Change Order 10 – City of Grand Ledge Iron Removal Plant, Description, and Impact

CONTRACT FOR: City of Grand Ledge Iron Removal Plant

BULLETIN
PAGE 1 OF 5

1. At Rooms 107 and 108 (See Sketch Below):

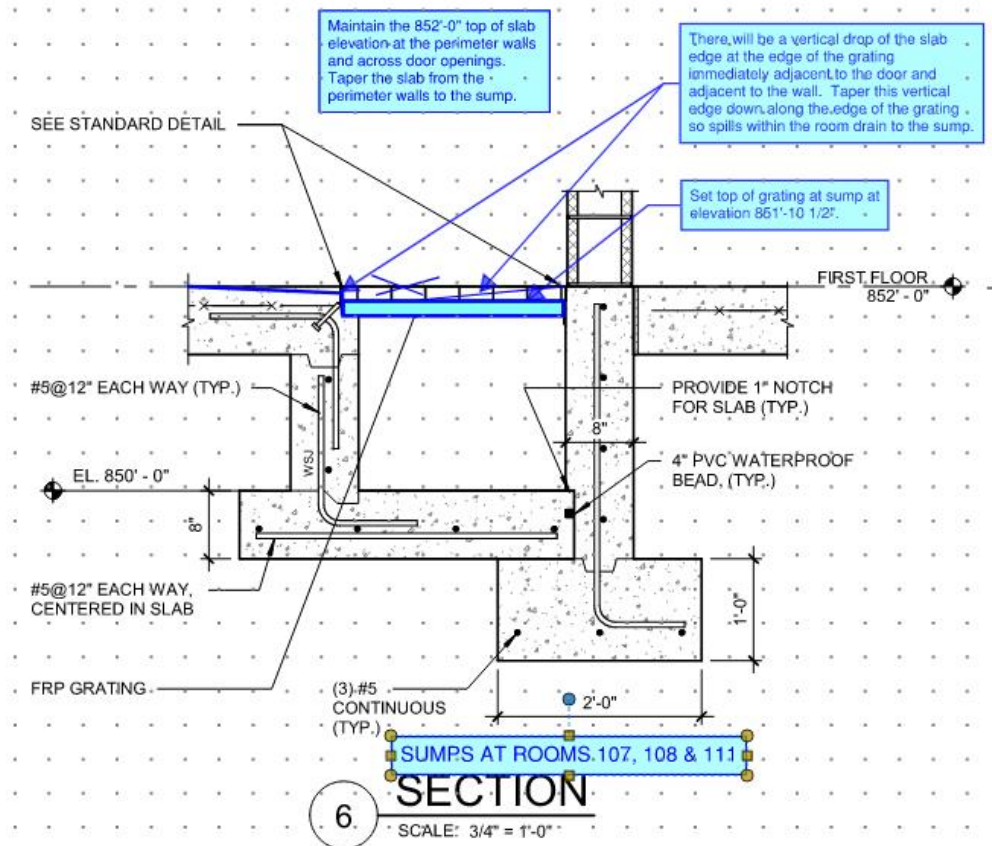
A. Clarification of Floor Slopes:

Set top of grating elevation at sump at elevation 851'-10 1/2", down 1-1/2" from the 852'-0" top of floor elevation at the edge of the rooms. Maintain the 852'-0" top of slab elevation at the perimeter walls and across door openings. Taper the slab from the perimeter walls to the sump. There will be a vertical drop of the slab edge at the edge of the grating immediately adjacent to the door and adjacent to the wall. Taper this vertical edge down along the edge of the grating so spills within the room drain to the sump.

2. At Room 111 (See Sketch Below):

Set top of grating elevation at sump at elevation 851'-10 1/2", down 1-1/2" from the 852'-0" top of floor elevation at the edge of the rooms. Maintain the 852'-0" top of slab elevation at the perimeter walls and across door openings. Taper the slab from the perimeter walls to the sump. There will be a vertical drop of the slab edge at the edge of the grating immediately adjacent to the walls. Taper this vertical edge down along the edge of the grating so spills within the room drain to the sump.

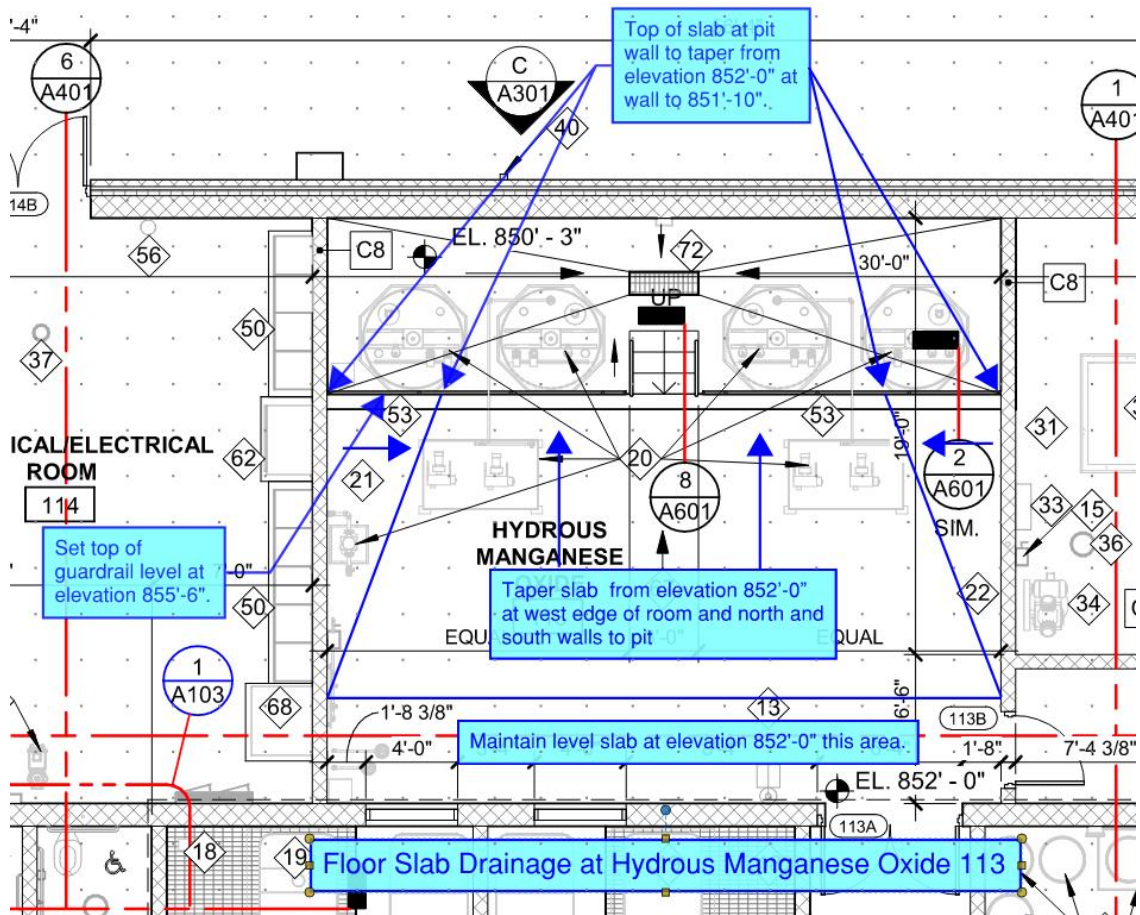
3. At Room 113 (See Sketch Below):
 It is our understanding that the concrete wall at the west edge of the pit is poured with the top of wall elevation at elevation 851'-6". Maintain a level slab at elevation 852'-0" along west edge of room. Top of slab at pit wall to taper from elevation 852'-0" at north and south walls to 851'-10". Taper slab from elevation 852'-0" at west edge of room and north and south walls to pit. Set top of guardrail level at elevation 855'-6".
